June 21, 2013

**Artarmon Progress Association submission - Ausgrid 132 kV North Shore upgrade project - 2 circuits from East Lindfield to Artarmon Industrial Area switchyard**

**APA objection to proposed route through Artarmon Reserve**

**Possible routes for the new Ausgrid circuits through Artarmon**

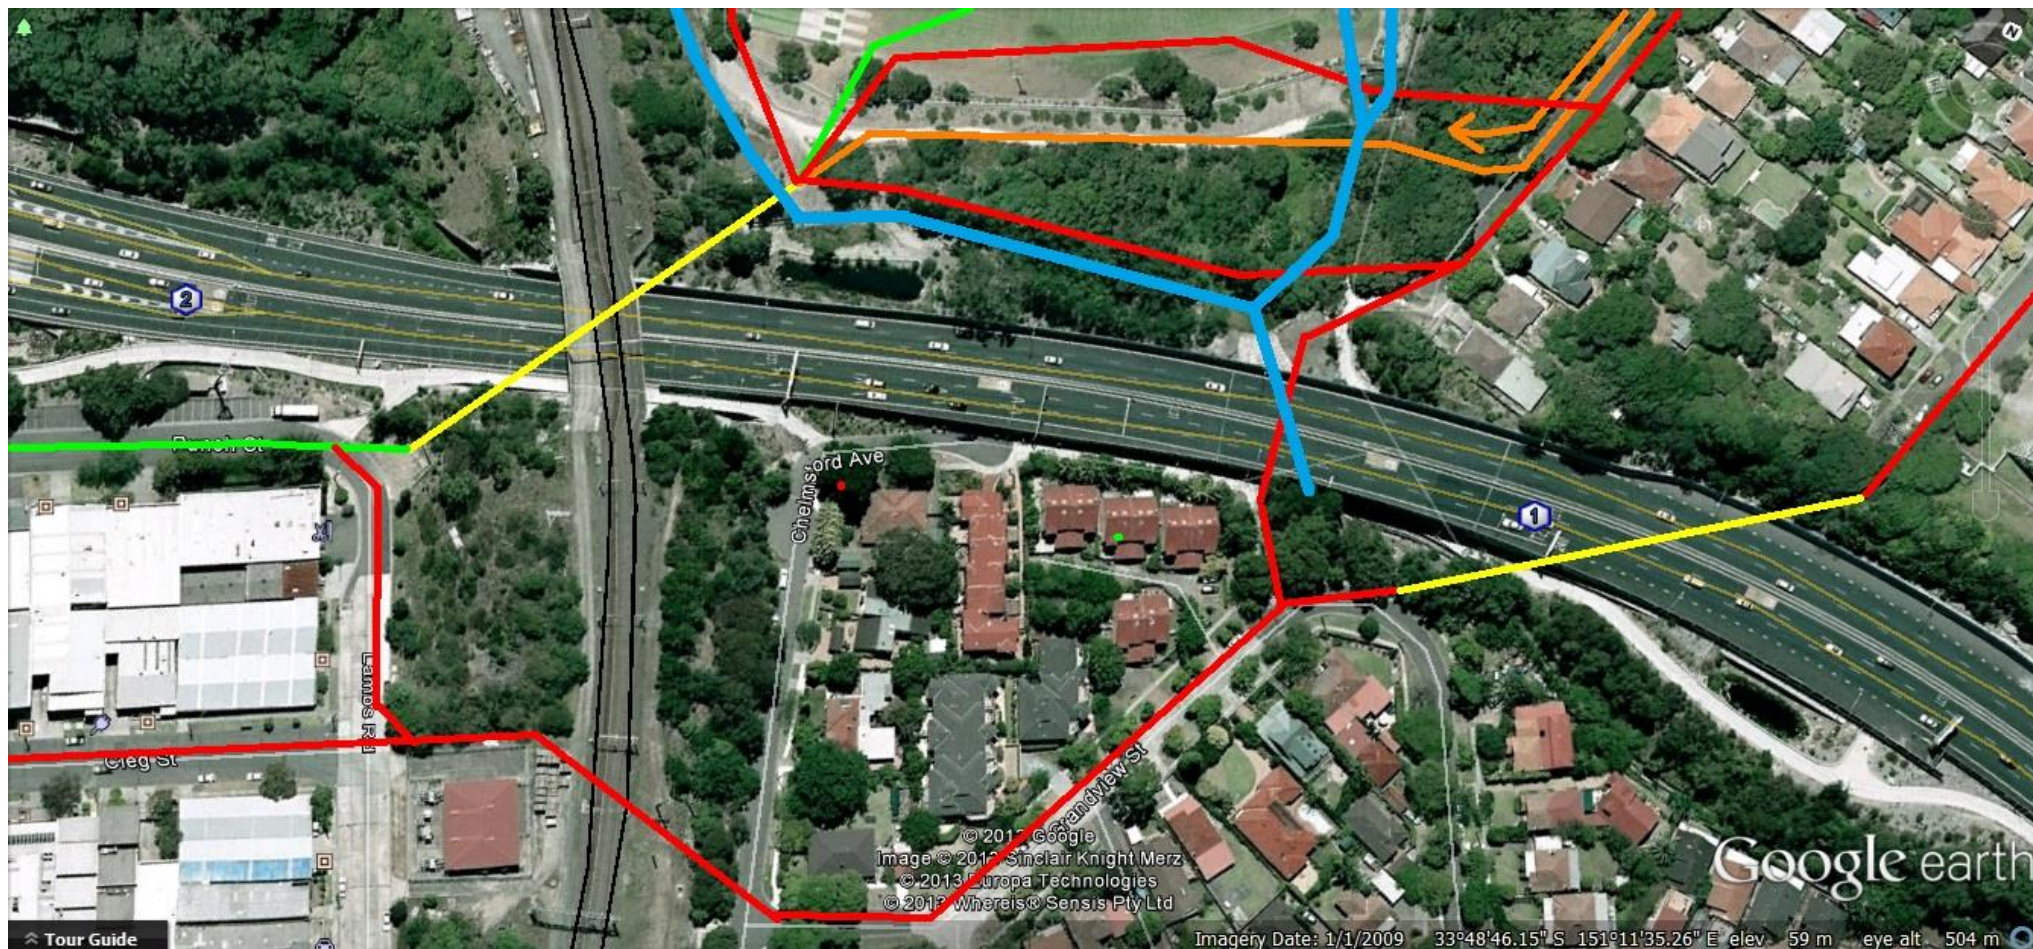
The figures below show the proposed Ausgrid cable route through Artarmon and possible alternate routes. Noting Ausgrid's reluctance to relocate the cables away from the Reserve, the APA favours a route proposed by Council.

This route runs along the north side of the manmade creek immediately north of the motorway. Council advises the vegetation along this route is of low value. Removing a six metre wide strip of vegetation for construction purposes, which will include twenty to thirty trees, in this location is acceptable to the APA. This route provides a level path to Chelmsford Ave. The restoration could include a gravelled walking path beside the creek.

Ausgrid advise there is insufficient space in the lower half of Chelmsford Avenue for two more circuits due the ground slope and other services. The APA proposes 150 metres of watermain serving the dozen properties in lower Chelmsford Ave be relocated closer to the property boundaries to provide room for the extra Ausgrid cables. The new watermain would go next to the kerb, or under the footpath. The cost of the watermain relocation is miniscule compared to the cost of the electrical circuits.

**Possible routes for the new Ausgrid circuits through Artarmon – motorway to stormwater retention basin wall**

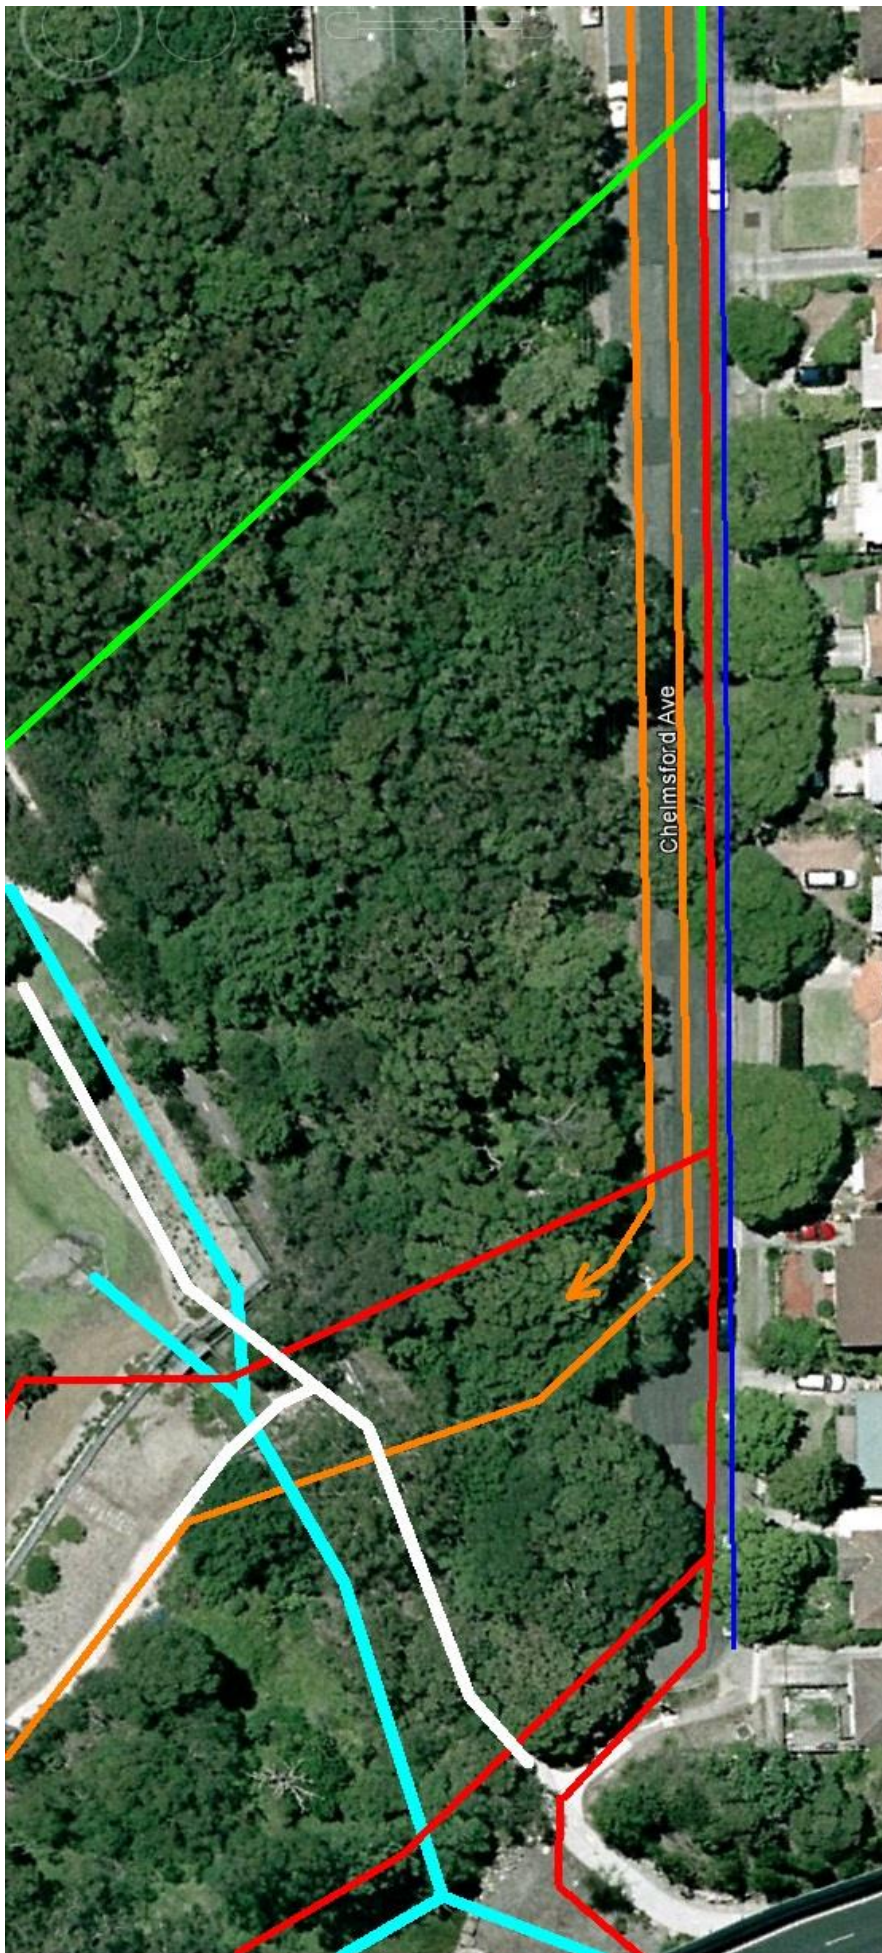
The Ausgrid route across the reserve includes a nearly 90 metre section through protected bushland on a steep slope (about 22 percent). This is extremely difficult terrain. While Ausgrid says they will only need a 6 metre wide clearing through the bush, the contractor will more likely need double that for the huge machinery necessary to do deep rock excavation on the slope. Only tracked machinery can work on the bottom half of the bushland crossing. Ausgrid should not be permitted to clear the bushland and excavate through the rock in this manner.
